Mr. Lowell Braxton, Director
Division of Oil, Gas and Mining
1594 West North Temple, Suite 1210
Box 145801
Salt Lake City, Utah 84114-5801Re: Emery Deep Mine Permit C/015/015
Deficiency responses
Amendment to MRP to abate NOV N03-39-1-1

Title: 4th East Portal Extension

**RESPONSES TO DOGM TECHNICAL ANALYSIS OF CONSOL
EMERY MINE AMMENDMENT DATED 9/12/03.**

PROPOSED TRUCK RE-ROUTING

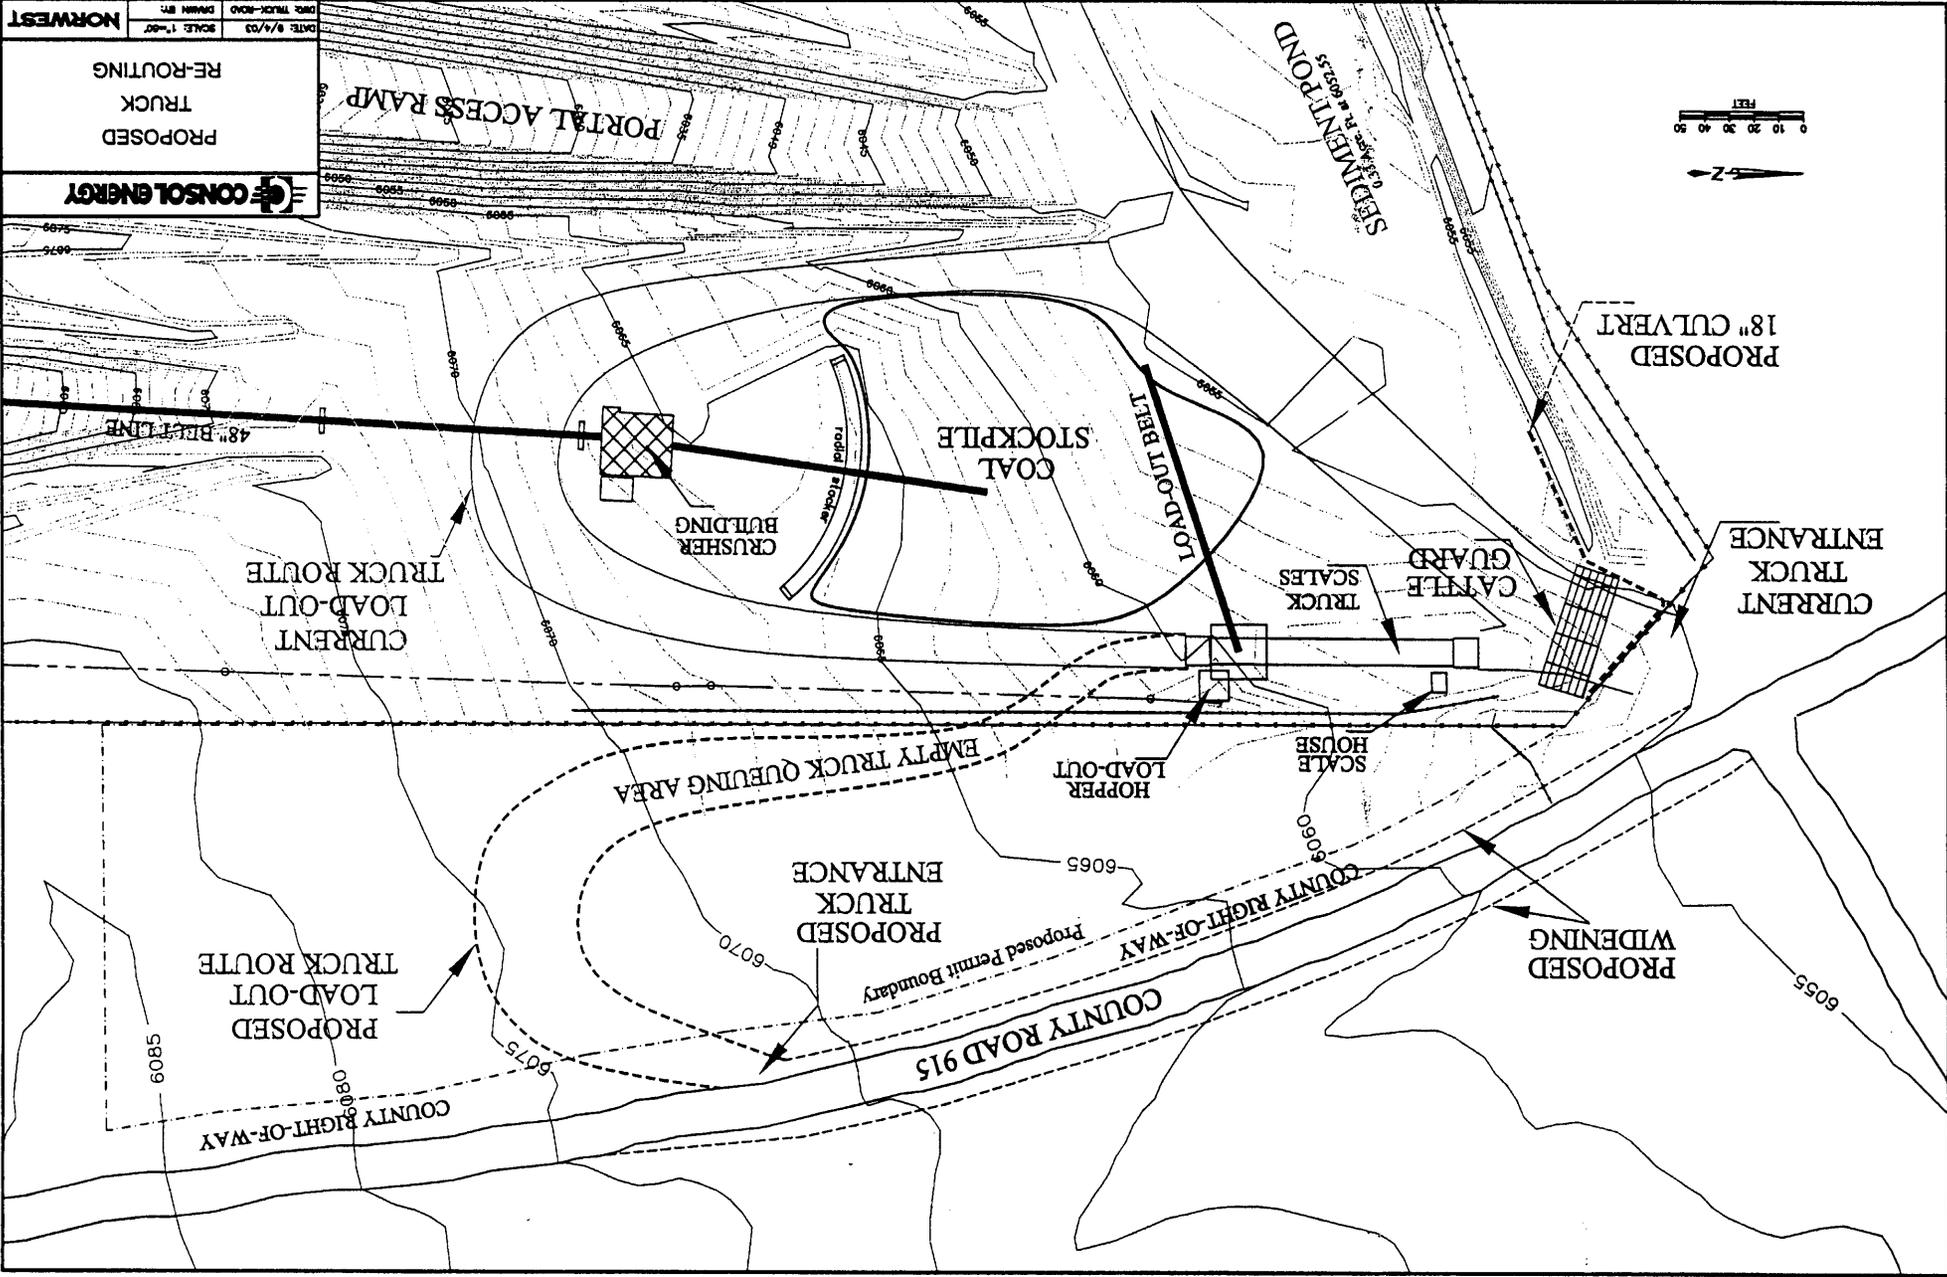
R645-301-526.116, THE PERMITTEE MUST STATE WHO WILL DO THE ROAD CONSTRUCTION WITHIN THE COUNTY'S RIGHT-OF-WAY. IF THE PERMITTEE DOES THE WORK THEN THEY MUST SHOW THAT THEY HAVE AN AGREEMENT WITH THE COUNTY. (THE COUNTY ENCROACHMENT PERMIT WAS ALSO REQUESTED UNDER R645-301-115.300 AND R645-103-234.100).

R645-301-526.220, THE EXPANSION OF THE COUNTY ROAD FOR REROUTING TRUCK TRAFFIC MAY BE EMPLOYED DURING PHASE 1 OR PHASE 2 OF THE DUST CONTROL STRATEGY, AT THE DISCRETION OF THE PERMITTEE, HOWEVER THE MAPS AND PLANS SUBMITTED WITH THIS APPLICATION SHOULD REFLECT THEM DIRECTION THE PERMITTEE WISHES TO TAKE.

Consolidation Coal company will be responsible for the road upgrade. A copy of the County Road Encroachment permit is attached.

The County Road re- route will be done under phase 1.
